From: [Aguilar, Julisa \(DTPW\)](#) on behalf of [Cleckley, Eulois \(DTPW\)](#)
To: [Hudak, Alina](#)
Cc: [Cueto, Josenrique \(DTPW\)](#); [Cleckley, Eulois \(DTPW\)](#); [Libhaber, Bruce \(CAO\)](#); [Alfonso, Annery \(CAO\)](#)
Subject: Ocean Drive Temporary Pedestrian Plaza
Date: Wednesday, October 11, 2023 9:29:37 AM
Attachments: [image001.png](#)
[Ocean drive temporary pedestrian plaza_10112023092548.pdf](#)

RE: Ocean Drive Temporary Pedestrian Plaza (Application No. 2022001803)

RE: Ocean Drive Temporary Pedestrian Plaza (Application No. 2022001803)

Exhibit 1

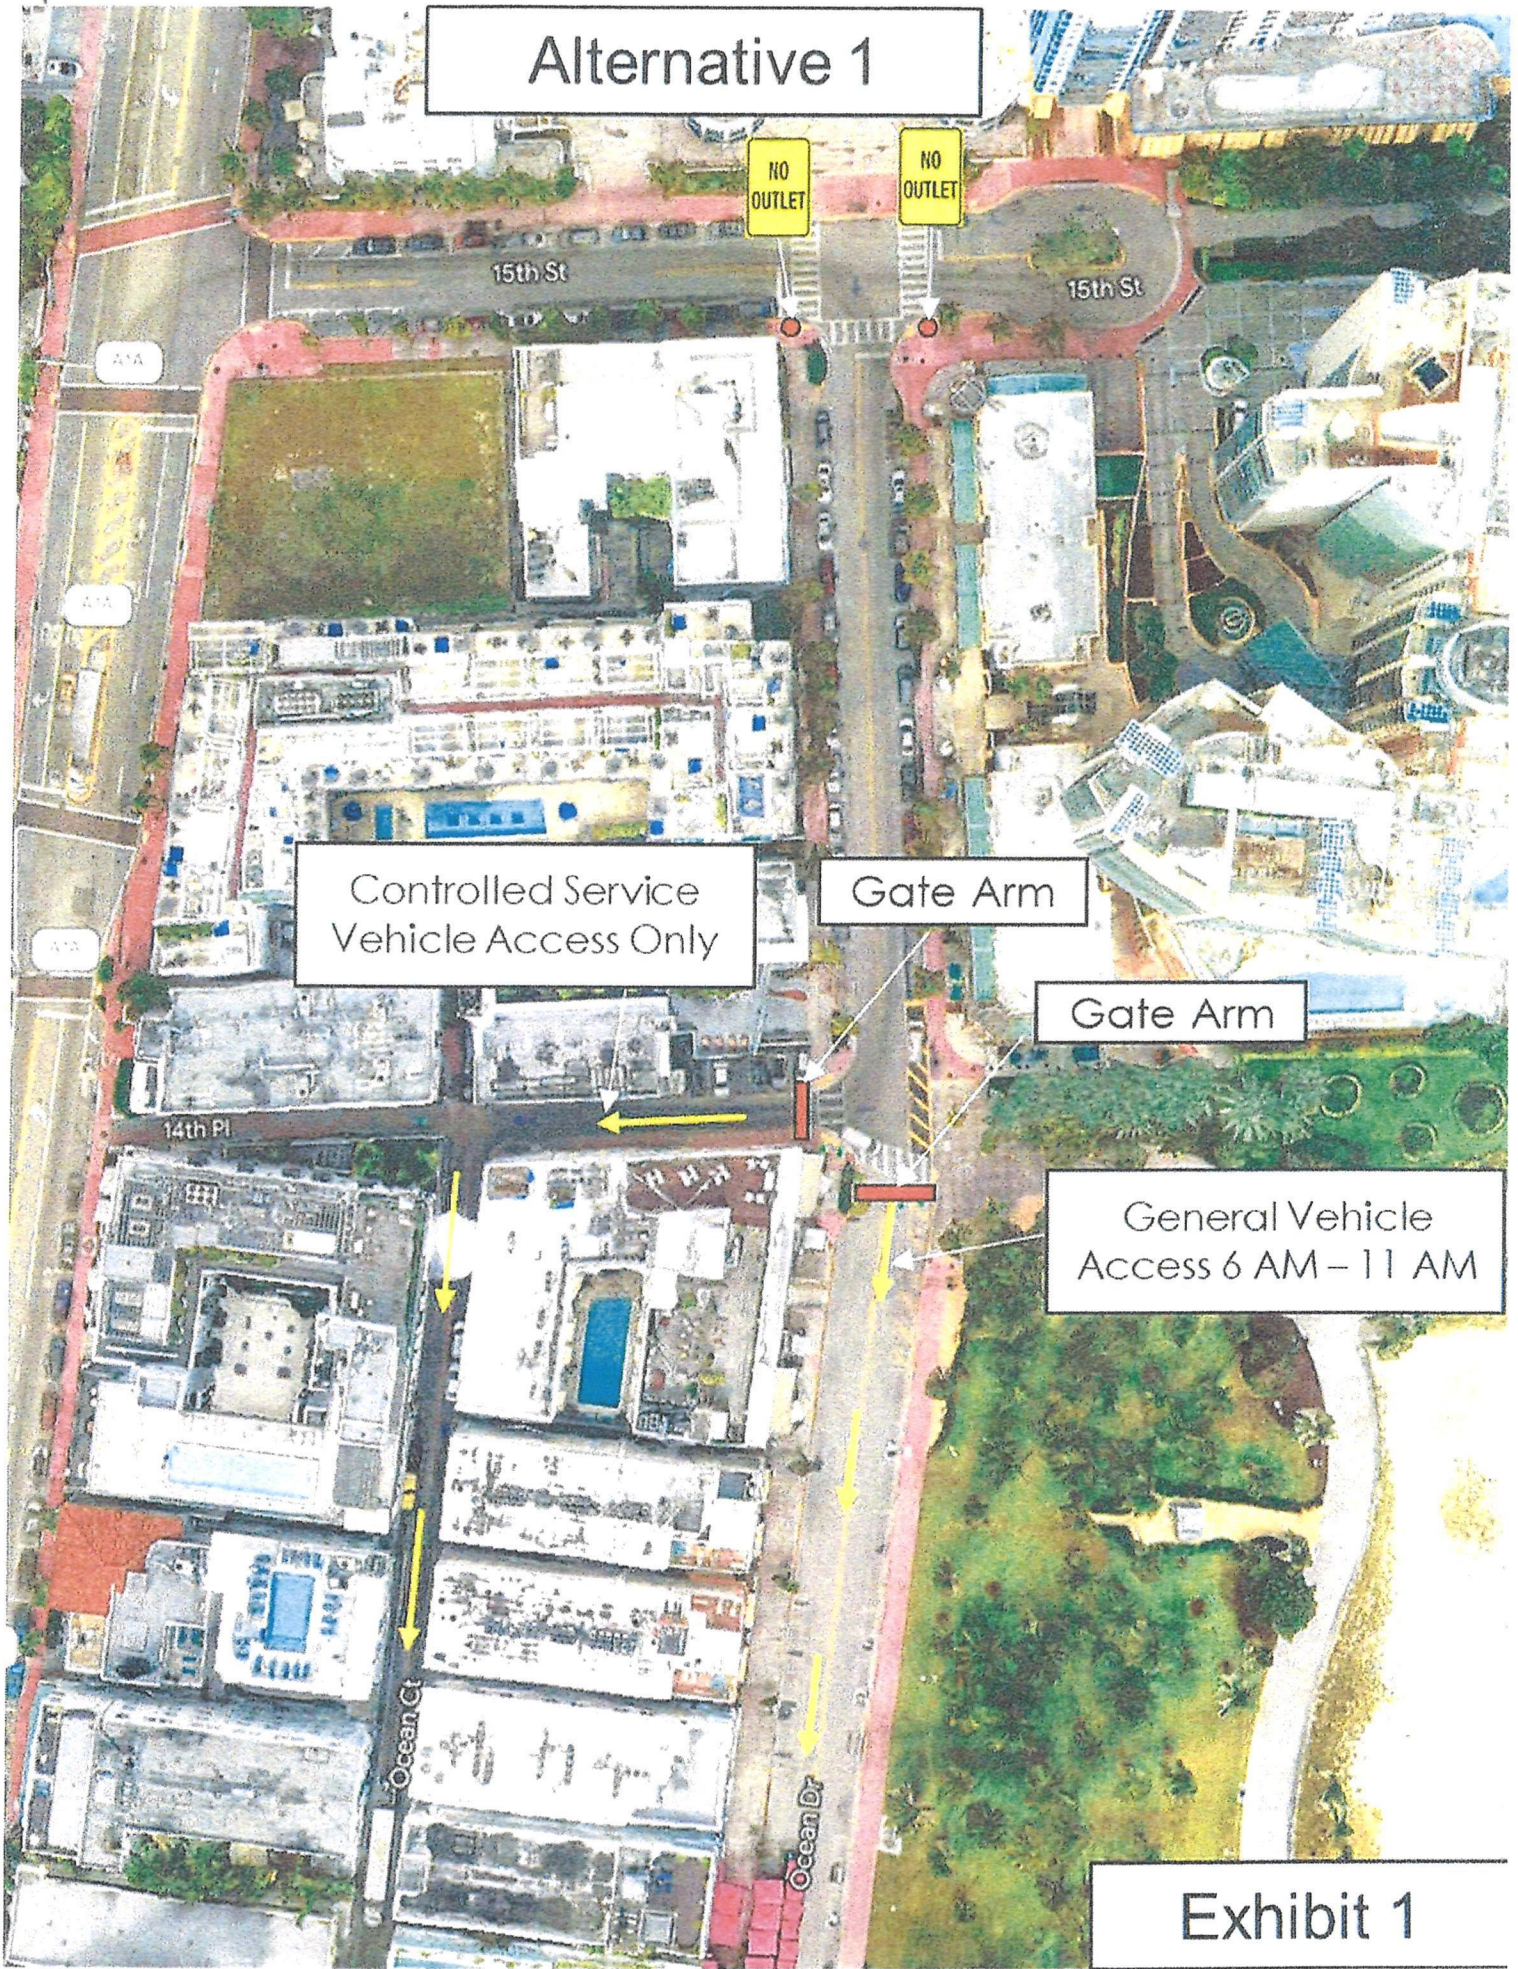
- Alternative 1: Gate closure at 14th Place and Ocar Drive with controlled access for service vehicles. See Exhibit 1.
- Alternative 2: Reconfiguration of the alleyway for northbound service vehicles traffic only. See attached Exhibit 2.

Both alternatives address DTPW's primary safety objective of limiting general traffic along the Ocean Ct. alleyway. Under these scenarios, A1A would serve as the alternate route for vehicular traffic. T-turnarounds would be required at the 13th and 14th Street alleyway intersections. As a result, traffic entering the intersecting streets will have an adequate method of egress and the Ocean Ct. alleyway would revert to its originally intended use for service vehicles only.
